Model: Martini-C1 Finisher (SR860/SR850)		Date: 13-Nov-02	No.: MB468001
Modified Article: Slide Rail Bracket Screw		Prepared by: M.Tsuyuki	
From: Technical Services sec. Service Planning Dept.			
Reason for Modification:	<input type="checkbox"/> Parts catalog correction	<input type="checkbox"/> Vendor change	<input type="checkbox"/> To meet standards ()
	<input type="checkbox"/> To facilitate assembly	<input checked="" type="checkbox"/> To improve reliability	
	<input type="checkbox"/> Part standardization	<input type="checkbox"/> Other

Model: Martini-C1 Finisher (SR860/850)		Date: 17-Dec-02	No.: MB468002
Modified Article: Tension Spring (B468 Only)		Prepared by: K. Miura	
From: Technical Services sec. Service Planning Dept.			
Reason for Modification:	<input type="checkbox"/> Parts catalog correction	<input type="checkbox"/> Vendor change	<input type="checkbox"/> To meet standards ()
	<input type="checkbox"/> To facilitate assembly	<input checked="" type="checkbox"/> To improve reliability	
	<input type="checkbox"/> Part standardization	<input type="checkbox"/> Other

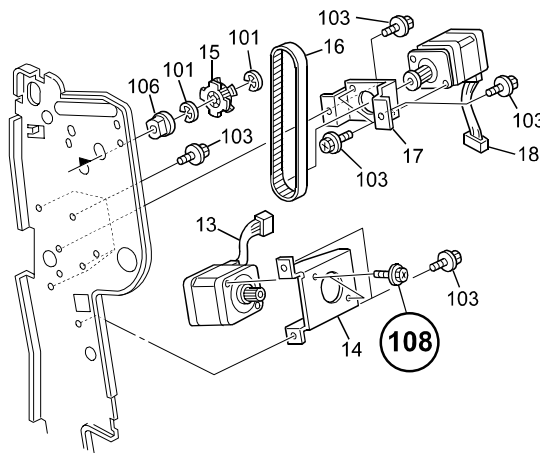
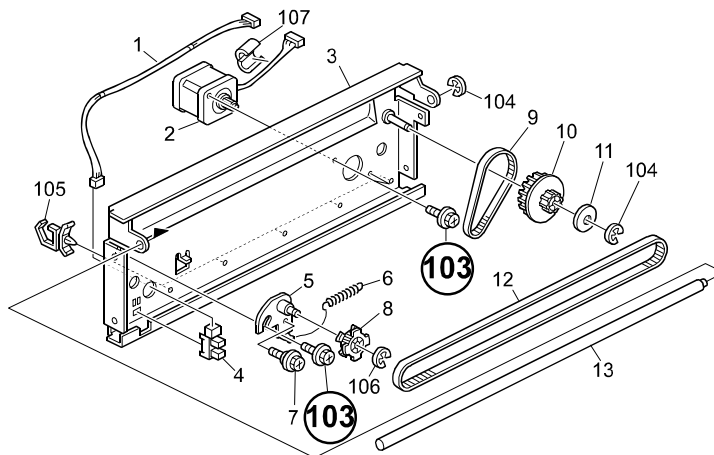
The following part has been changed to facilitate assembly.

Old part number	New part number	Description	Q'ty	Int	Page	Index	Note
04513006B		Tapping Screw - M3x6			23	103	
	09503005B	Phillips Screw With Spring Washer		X/O	27	108

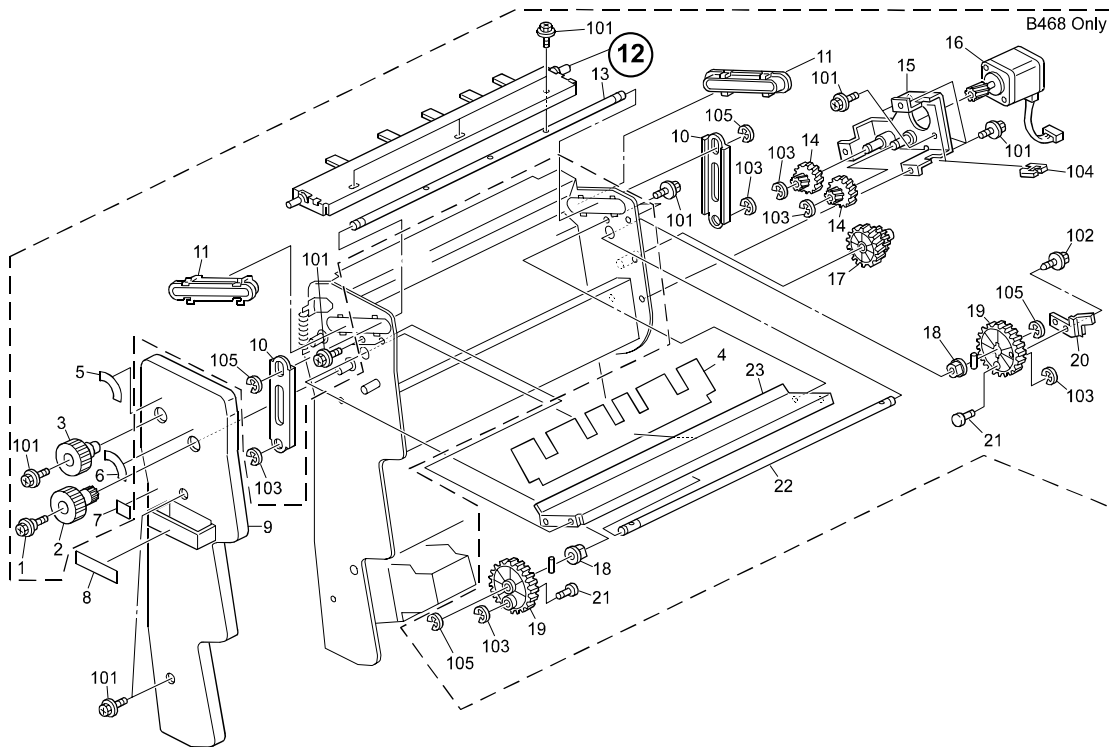
The following paper-folding bracket has been changed to ensure that its Teflon layer does not dirty the paper, which can occur during the early period following finisher installation.

Old part number	New part number	Description	Q'ty	Int	Page	Index	Note
B4684711	B4684716	Bracket	1	X/O	29	12

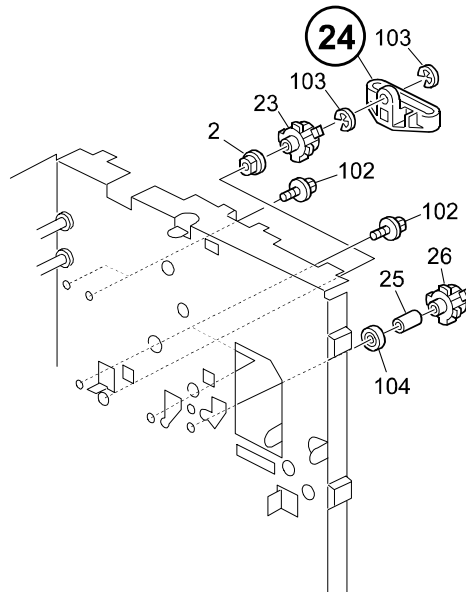
The following part has been changed to increase durability.

Old part number	New part number	Description	Q'ty	Int	Page	Index	Note
B4082314	B4682415	Arm - Roller Slide	1	X/O	13	24

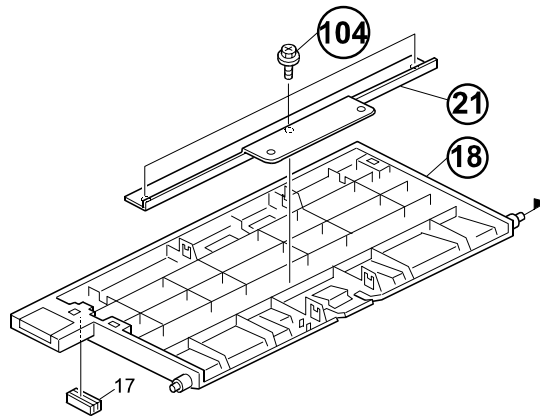
The following have been changed to ensure warping does not develop in the Guide Plate.

Old part number	New part number	Description	Q'ty	Int	Page	Index	Note
B4682172	B4682174	Guide Plate	1	X/X	11	18	
	B4682175	Supporting Plate	1		11	21	
	04504008B	Tapping Screw - 4x8			11	104

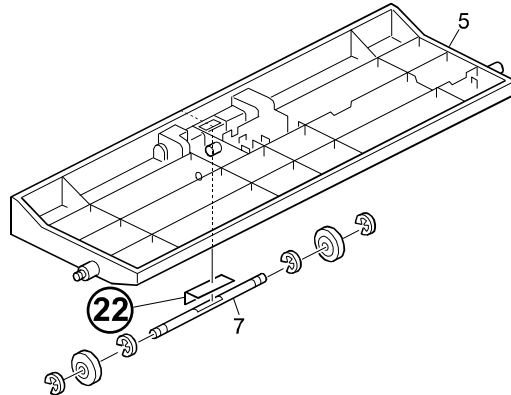
The following has been added to improve the durability of the Exit Guide Plate (B4682811, P/C pg. 11, #5) when used on the Bellini-C2.

Old part number	New part number	Description	Q'ty	Int	Page	Index	Note
	B4682835	Mylar - Exit Roller Shaft	1		11	22

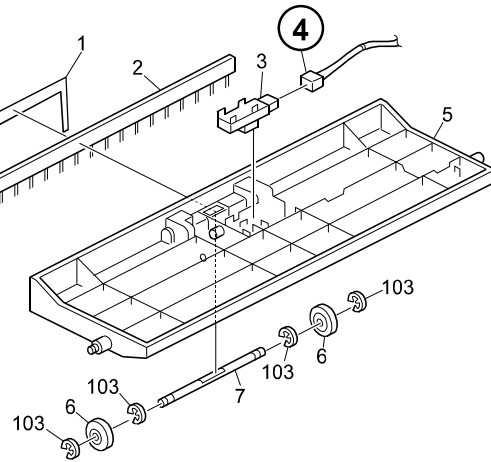
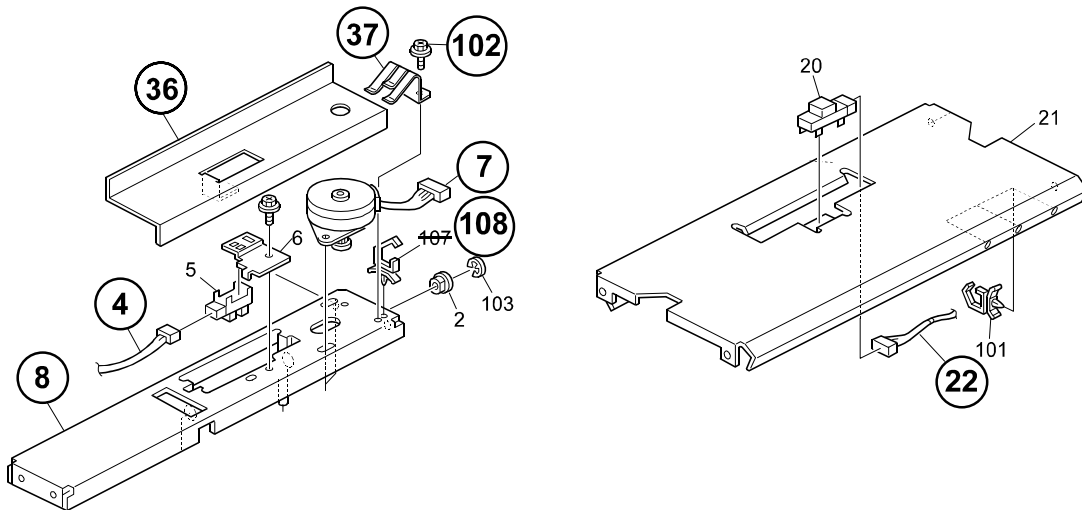
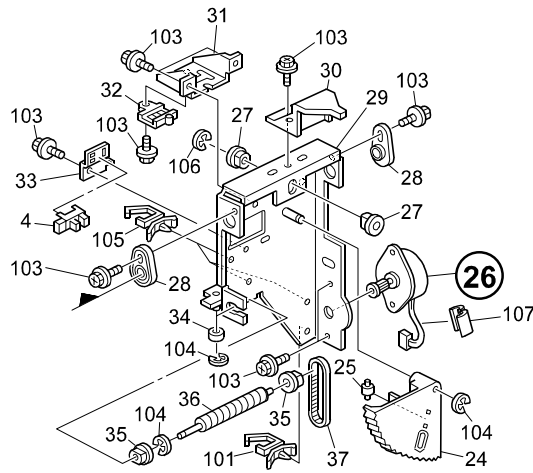
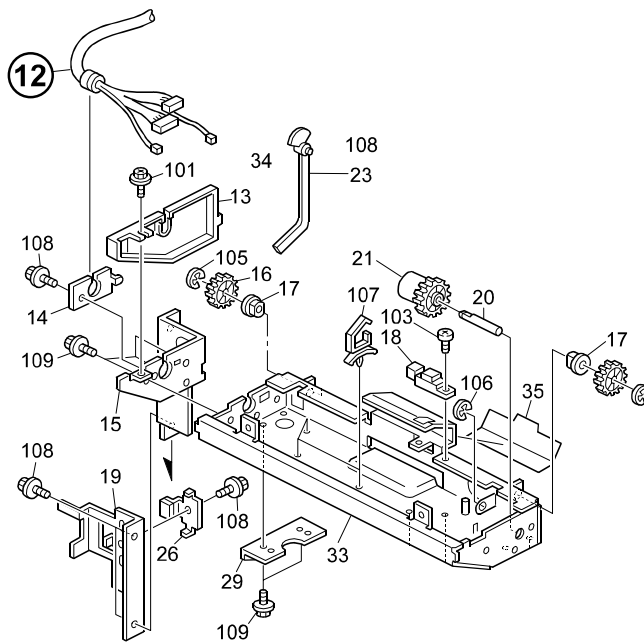
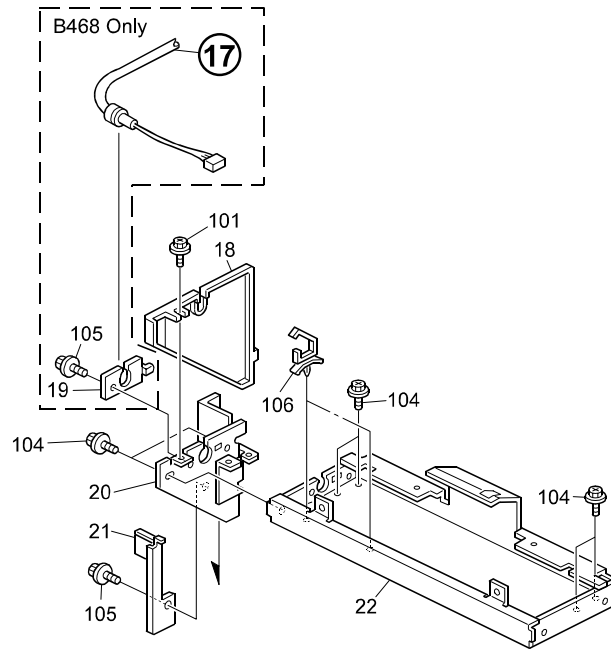
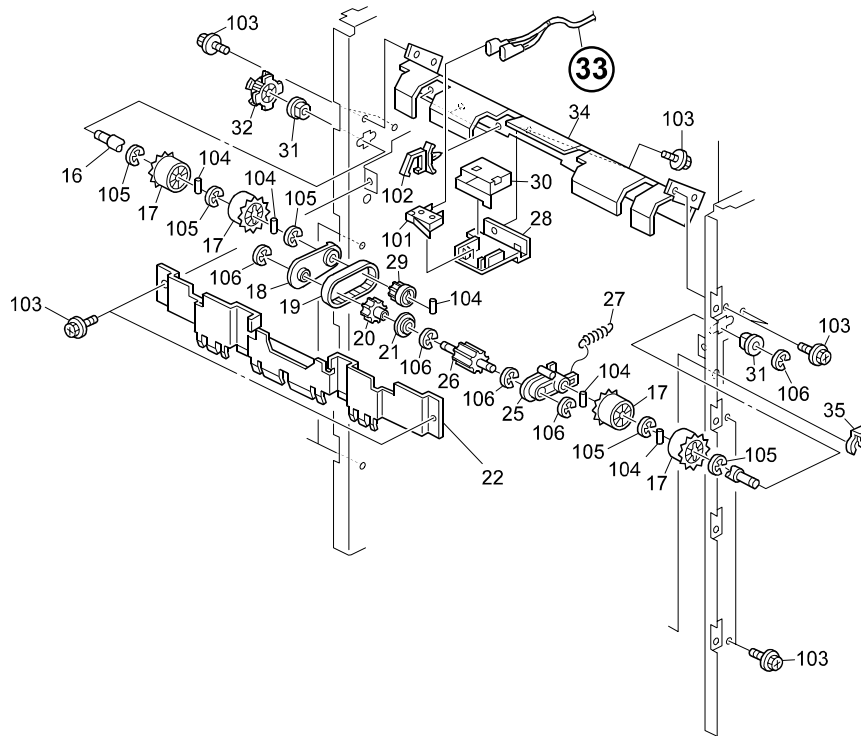
The following have been changed to conform to the high specification heat standards on the Bellini-C2.

Old part number	New part number	Description	Q'ty	Int	Page	Index	Note
B4685422	B4685522	Exit Harness	1	X/O	11	4	
B4685423	B4685523	Guide Harness	1	X/O	13	4	
B4085520		Stepper Motor	1		13	7	
	B4685780	Stepper Motor - DC 20.4W	1	X/O	13	7	
B4682851	B4682848	Guide Plate Stay	1	X/O	13	8	
B4685422	B4685522	Exit Harness	1	X/O	13	22	
	B4682897	Heat Sink - Guide Plate	1		13	36	
	B4682899	Plate - Heat Sink	1		13	37	
	04513006B	Tapping Screw - M3x6			13	102	
11050487		Harness Clamp			13	107	
	11050348	Clamp		X/O	13	108	
B4085520		Stepper Motor	1		27	26	
	B4685780	Stepper Motor - DC 20.4W	1	X/O	27	26	
B4685470	B4685570	Upper Tray Harness	1	X/O	33	12	
B4685474	B4685574	Lower Tray Harness	1	X/O	35	17	
B4685473	B4685583	Lower Motor Harness	1	X/O	37	33	
B4682421	B4682418	Motor Bracket	1	X/O	39	4	
B4085520		Stepper Motor	1		39	5	
	B4685780	Stepper Motor - DC 20.4W	1	X/O	39	5	
	11050511	Harness Clamp-LW50306ZC	1		39	103	
	B4682429	Heat Sink-Motor Roller Shift	1		39	35

B4682899	Plate - Heat Sink	1		39	36	
B4685991		Harness Bracket	8->7		43	5	
B4685420	B4685520	Main Sensor Harness (B468)	1	X/O	43	9	
B4685410	B4685510	Main Motor Harness	1	X/O	43	13	
B4685490	B4685590	Interface Harness - Option	1	X/O	43	14	
B4685460	B4685560	Harness - Punch Unit	1	X/O	43	15	
B4685478	B4685578	Upper Motor Harness (B468)	1	X/O	43	20	
04513006B		Tapping Screw - M3x6			43	101	
11050488		Harness Clamp			43	103	
	11050487	Harness Clamp			43	105	
	11050516	Clamp			43	106

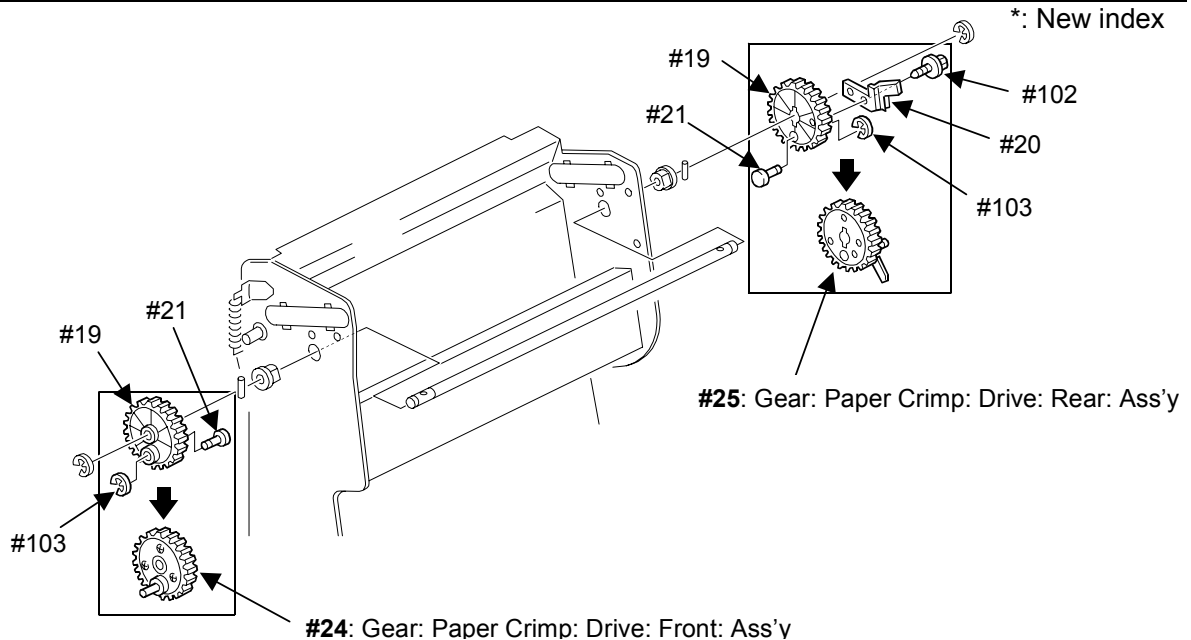
To ensure the Drive Gear is not damaged, support plates have been added to both sides. To facilitate serviceability, the parts below are supplied as assemblies.

Old part number	New part number	Description	Q'ty	Int	Page	Index
B4684742		Drive Gear	1 - 0	X/	29	19
B4684743		Link Shaft	1 - 0			21
07200040B		Retaining Ring – M4	n - n-1			103
	B4684741	Gear: Paper Crimp: Drive: Front: Ass'y	0 - 1	/O		*24
B4684742		Drive Gear	1 - 0	X/	29	19
B4684732		Shielding Plate Bracket	1 - 0			20
B4684743		Link Shaft	1 - 0			21
04503008B		Tapping Screw - M3x8	n - n-1			102
07200040B		Retaining Ring – M4	n - n-1			103
	B4684731	Gear: Paper Crimp: Drive: Rear: Ass'y	0 - 1	/O		*25

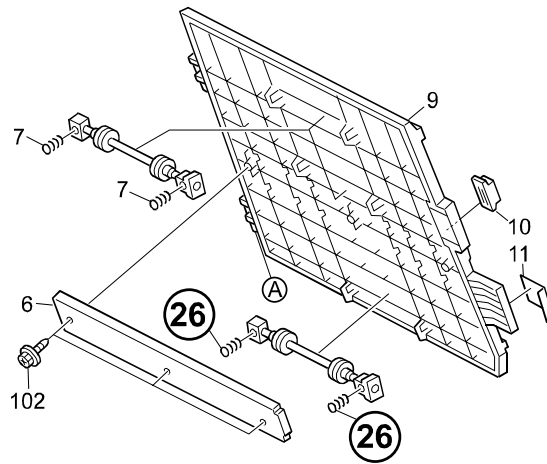
The following have been changed to minimize jams with tab sheets.

Old part number	New part number	Description	Q'ty	Int	Page	Index	Note
AA063529	AA063529	Pressure Spring - 14.5mm	6->4	-	17	7	
	A6972187	Pressure Spring - 14.1mm	2	X/O	17	26

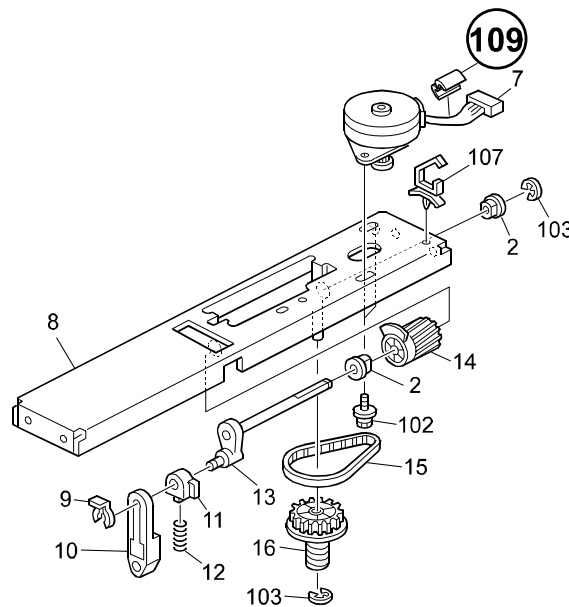
The following has been added to prevent static-electrical noise.

Old part number	New part number	Description	Q'ty	Int	Page	Index	Note
	16070623	Ferrite Core - TFC-16-8-13	1		13	109

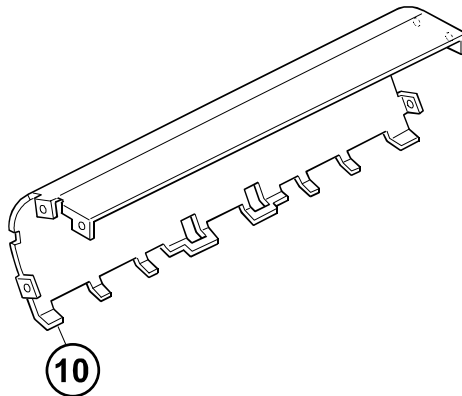
The Lower Guide Plate has been changed so that its junctions do not bend and cause a paper jam.

Old part number	New part number	Description	Q'ty	Int	Page	Index	Note
B4682116	B4682120	Lower Guide Plate	1	X/O	11	10

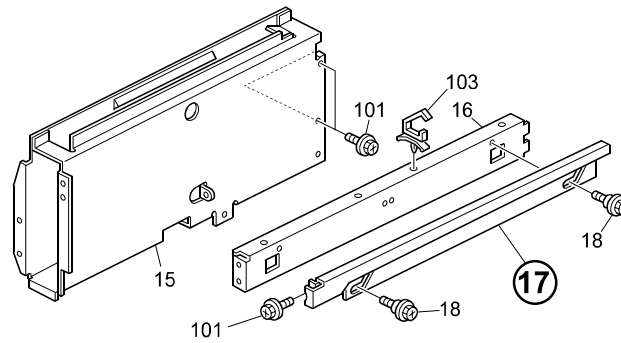
The following has been changed to confirm to Ricoh internal performance standards.

Old part number	New part number	Description	Q'ty	Int	Page	Index	Note
A6971127	A6971128	Joint Lever	1	X/O	9	17

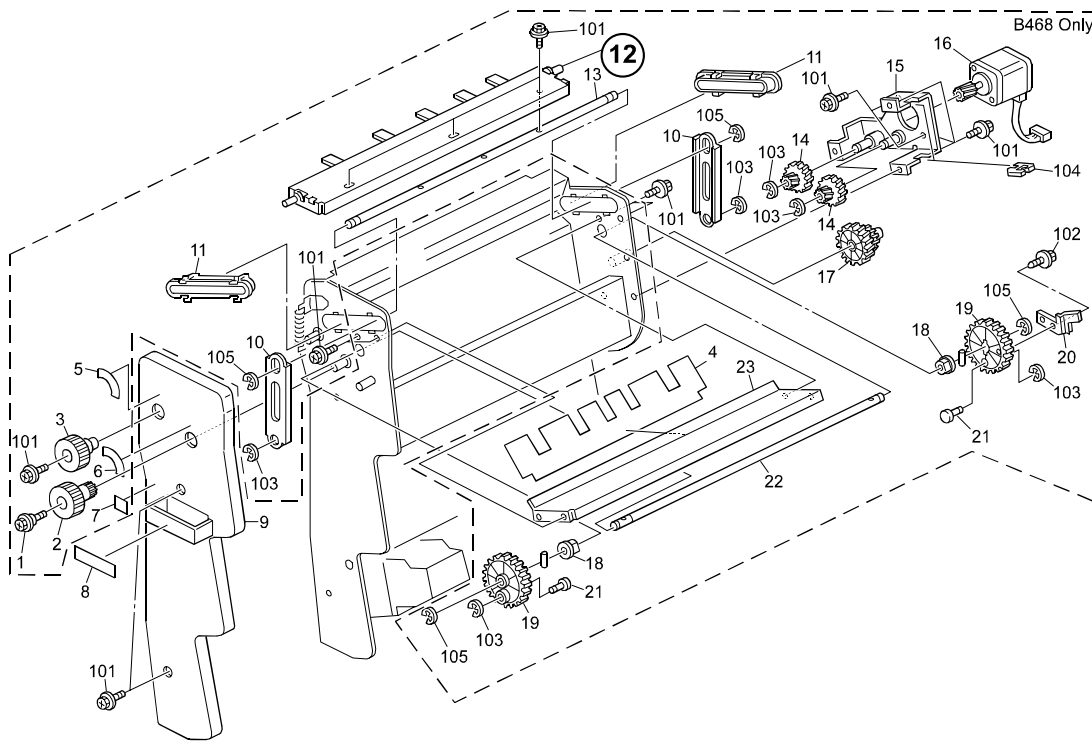
The paper-folding bracket has been changed to further minimize damage to the paper.

Old part number	New part number	Description	Q'ty	Int	Page	Index	Note
B4684711	B4684716	Bracket	1	X/O	29	12

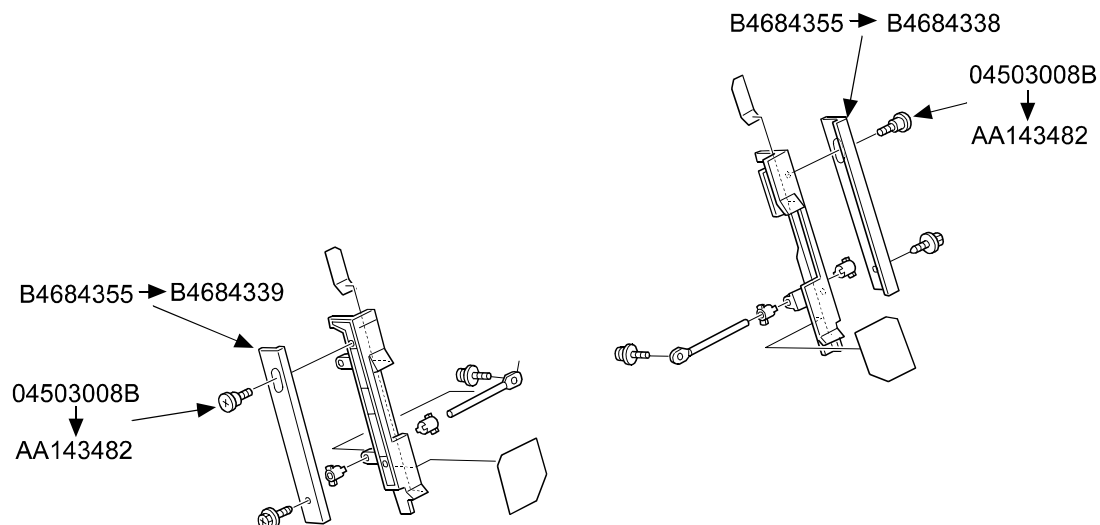
The following modifications have been made to ensure the jogger fences stay properly aligned even if the plastic expands by heat:

- The screw holes in the metal support plates for the fences have been lengthened to allow the jogger fence to expand.
- The shapes of the front and rear support plates have been changed.
- The upper screw for the plate and jogger fence has been changed to a stepped screw.

Old part number	New part number	Description	Q'ty	Int	Page	Index	Note
B4684335		Protect Bracket	2-0		21	1	
	B4684339	Support plate – front jogger fence	0-1		21	1	A
	B4684338	Support plate – rear jogger fence	0-1		21	31	A
04503008		Tapping Screw – M3x8			21	101	A

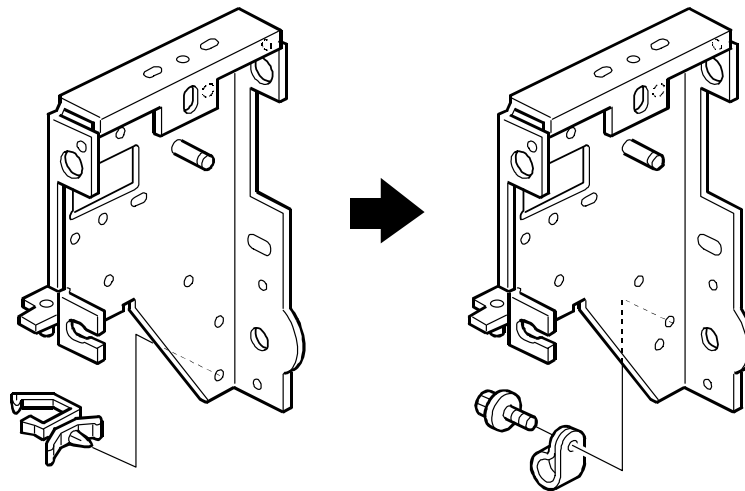
The moving bracket was changed to facilitate assembly.

Old part number	New part number	Description	Q'ty	Int	Page	Index	Note
B4684531	B4684532	Moving Bracket	1	X/O	27	29

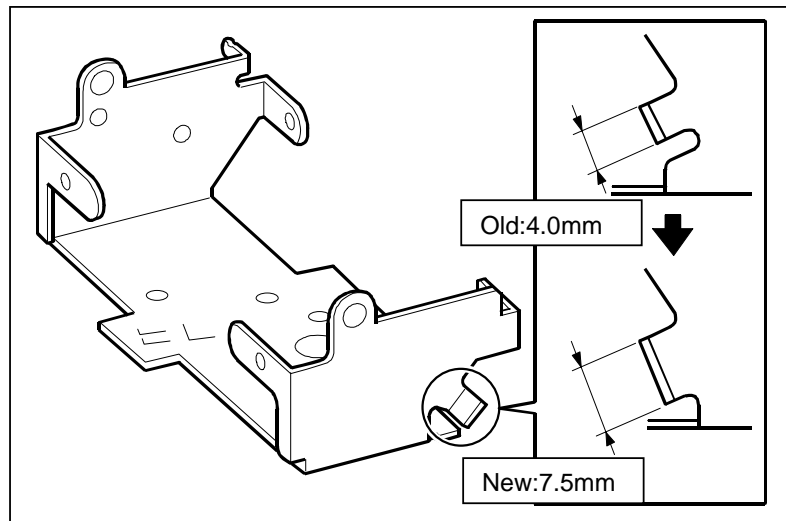
The bracket has been modified to prevent the home position error.

Old part number	New part number	Description	Q'ty	Int	Page	Index	Note
B4683831	B4683825	Bracket	1	X/O	37	6

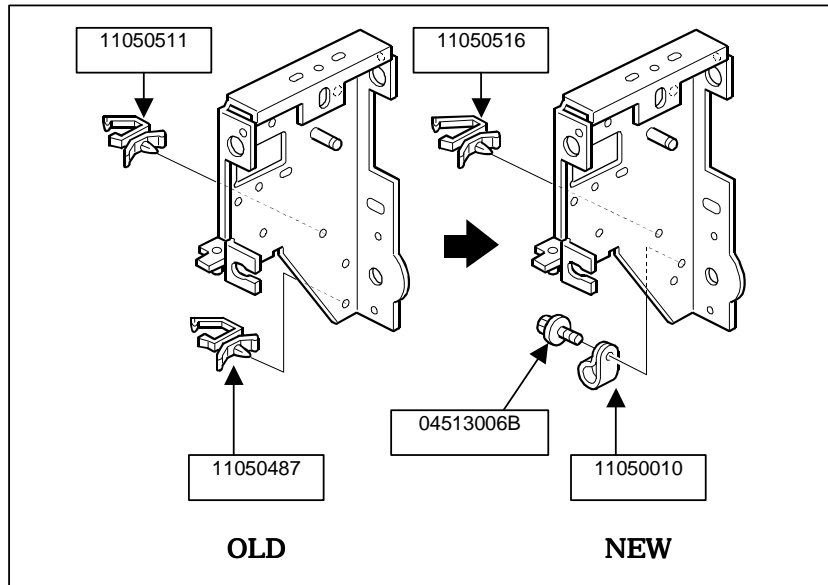
The moving bracket has been changed to facilitate assembly.

Old part number	New part number	Description	Q'ty	Int	Page	Index	Note
B4684531	B4684532	Moving Bracket	1	X/O	27	29	
11050487		<i>Harness Clamp</i>	<i>n->n</i>	<i>X/O</i>	<i>27</i>	<i>101</i>	
	11050010	<i>Harness Clamp – 6N</i>					
	04513006B	<i>Tapping Screw – M3*6</i>	<i>0->n</i>	<i>-</i>	<i>-</i>	<i>-</i>	
11050511	11050516	<i>Harness Clamp</i>	<i>n->n</i>	<i>O/O</i>	<i>27</i>	<i>105</i>
